**TOWN OF NEWBURGH
PLANNING BOARD**

PROJECT NAME: **UNITY PLACE WAREHOUSE SWPPP**
PROJECT NO.: **21-29**
PROJECT LOCATION: **NORTHWEST CORNER OF OLD LITTLE BRITAIN RD. & UNITY WAY
SECTION 97, BLOCK 2, LOT 14.1 , 19.12, 37.2**
REVIEW DATE: **16 MAY 2023**
MEETING DATE: **18 MAY 2023**
PROJECT REPRESENTATIVE: **BROOKER ENGINEERING**

Planting Plan Comment Review

Following are Brooker Engineering's responses to the 12/29/22 review Memorandum from Karen Arent, Landscape Architect Items 1,2,4-12. Attached please find Anderson Design Group's response to Items 3, 13-15.

FIELDSTONE WALL DETAIL
N.T.S.

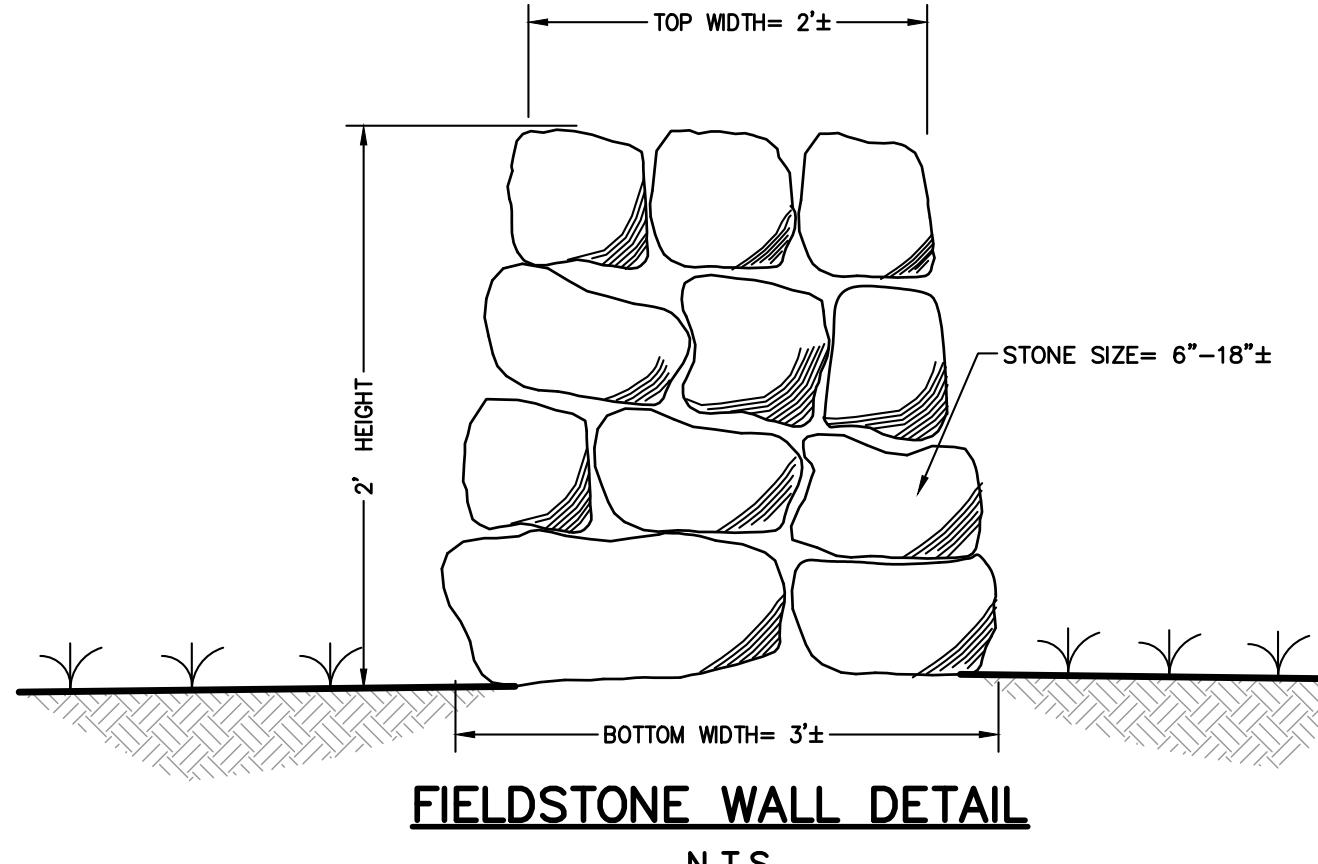
6. **Comment:** The stone wall along Unity Place will help screen views of the parking area, however, views of the building will not be screened at all. Plans should include details of the stone wall. Medium sized shrubs, spaced 15' apart (it will take at least a decade for them to grow together in optimal conditions) are proposed in a straight line between the stone wall and bioretention facility. They should be spaced a minimum of 5' apart and street trees, spaced 40' on center, should be shown. Street trees, spaced 40' on center, should continue along Unity Place.

- a) The Fieldstone parapet wall detail is provided on Detail Sheet 6.
- b) The spacing of medium sized shrubs has been decreased to 5 feet on center.
- c) Street trees and evergreens have been indicated along Unity Place at a maximum spacing of 40 feet on center depending upon the species. Specific details of the revised street tree and evergreen planting along Unity Place is indicated in our response to Comment 4 above.
